NRSS XXXVI Transmission Limited

Ref: NRSS XXXVI/DEL/2018/ 74

Dated: 5th April, 2018

Sub: System Strengthening Scheme in Northern Region (NRSS - XXXVI) – Traversing of 400 KV D/C Koteshwar – Rishikesh Transmission Line through the premises of Indian Drugs and Pharmaceuticals Limited (IDPL), Rishikesh.

OWNER	NRSS XXXVI TRANSMISSION LTD.
PROJECT	System Strengthening Scheme in Northern Region (NRSS-XXXVI) along with LILO of Sikar-Neemrana 400kV D/C Line at Babai (RRVPNL)
LINE NAME	KOTESHWAR POOLING STATION - RISHIKESH 400kV D/C (TWIN HTLS) TRANS. LI

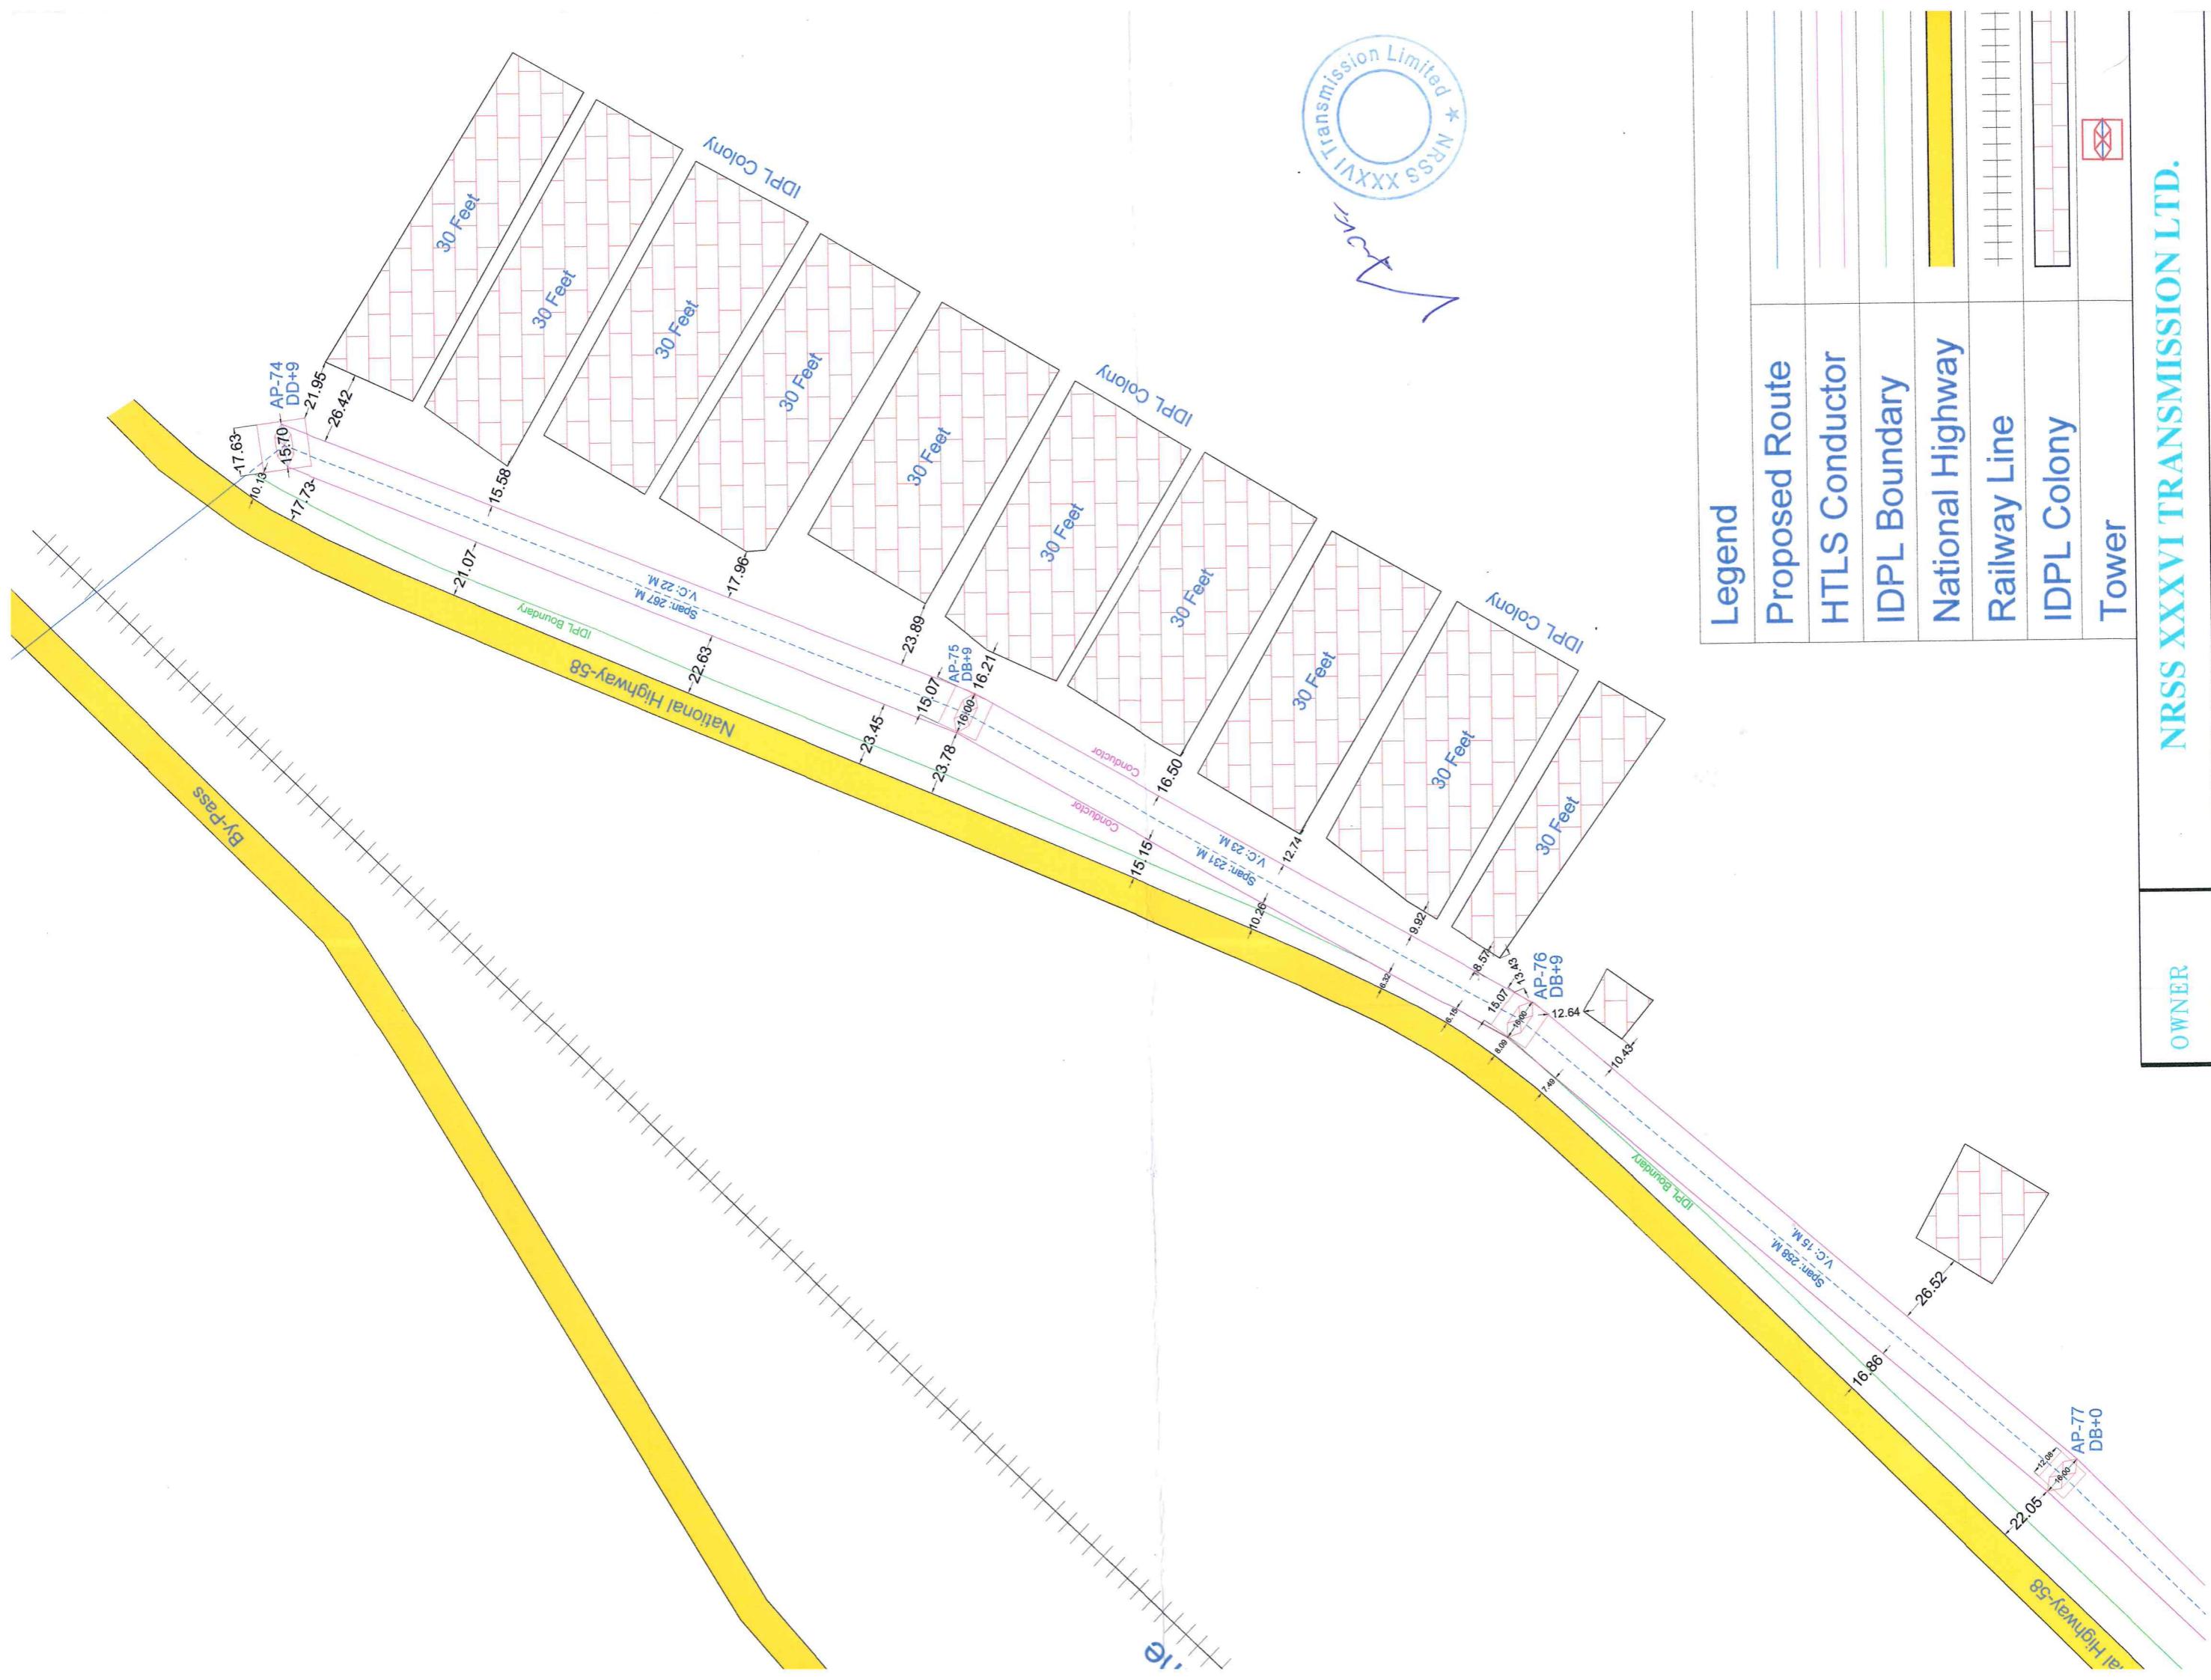
As per discussions held in the meeting, the locations of Towers from AP 74/0 to AP 76/0 of the line has been shifted towards the IDPL boundary so that max. horizontal clearance is maintained from the nearest building.

The revised route map drawing from AP 74/0 to AP 77/0 specifying the clearance from nearest building is also enclosed.

After incorporating the suggested changes as discussed in the meeting, the revised co-ordinates for the locations falling inside the IDPL premises are as under:

Sl. No	AP. Nos.	Tower Type	UTM Coordinate		Angle of Deviation	Span Length
			Easting	Northing		
1	AP-74	DD+9	236145	3331175	59°28'58.7"	267
2	AP-75	DB+9	236044	3330928	7°32'7.7"	231
3	AP-76	DB+9	235929	3330727	11°2'59"	258
4	AP-77	DB+0	235761	3330531	4°52'22.8"	257
5	77/1	DA+0	235580	3330349		258
